# Response to proposed path of the Seismic Task Group

By Marlou B. Rodriguez, P.E., S.E  
Engineering Manager, Anchor Systems

# Proposal to replace existing seismic qualification with ASPC2 of AC510

Fig. 3—SMRF building designs (note: base of model and column bottom are fixed).

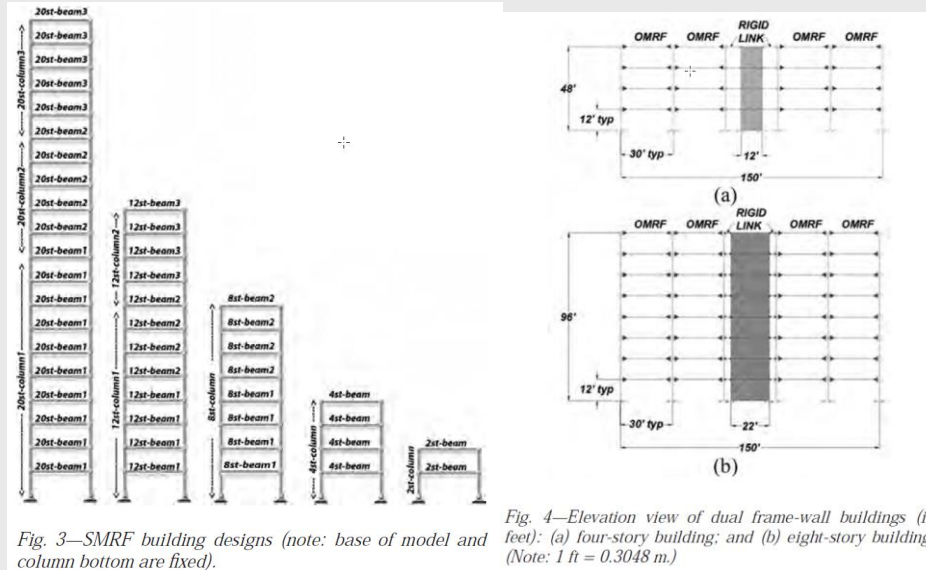
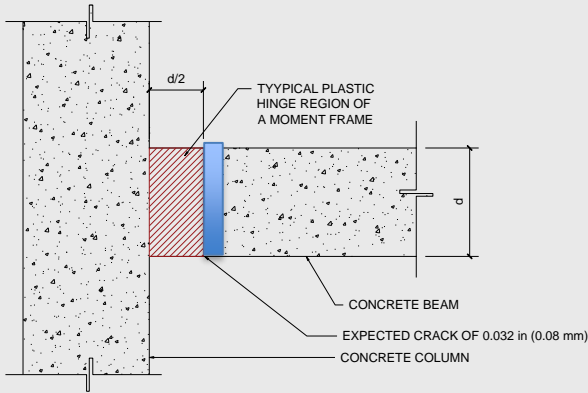
- Justification of movement protocol and crack widths were derived from 2d frame concrete special moment frames and ordinary moment frames coupled with concrete shearwalls.
